# NFPA 805 OBSERVATION VISIT TRIP REPORT

**Location:** Oconee Nuclear Station, Seneca, South Carolina

**Subject:** Risk-Informed, Performance-Based Fire Protection Transition Pilot-Plant Observation Visit - Oconee Nuclear Station

Figure 1. Multiple Spurious Post-Transition Inspections

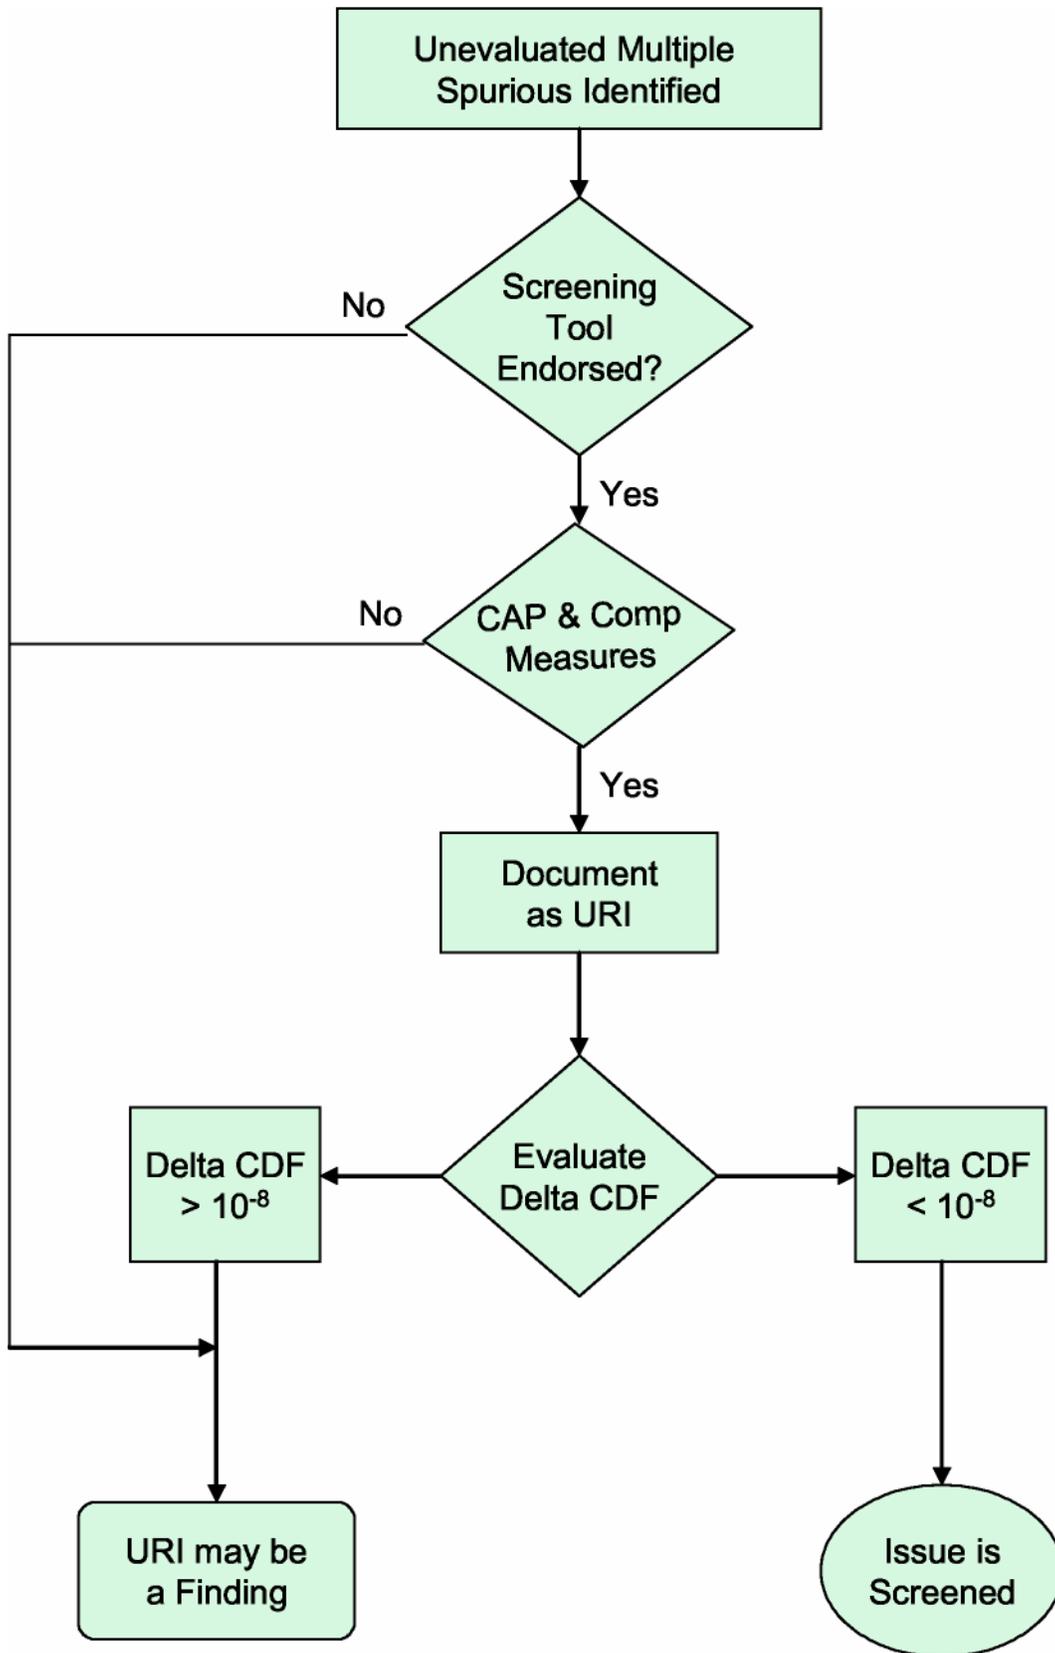
At the March 2006 pilot plant observation visit, the Staff presented a flow chart, illustrating how newly found multiple spurious circuits identified during an inspections, could be treated (See flow chart below). In addition to the flowchart, the following information was discussed:

**Resolution Action(s)/Action Party:** OPEN. Industry and pilot-plant participants agreed to review the flowchart, IMC 0612 questions, screening thresholds and provide feedback to the NRC at the next observation visit. The industry may also submit an FAQ on the issue.
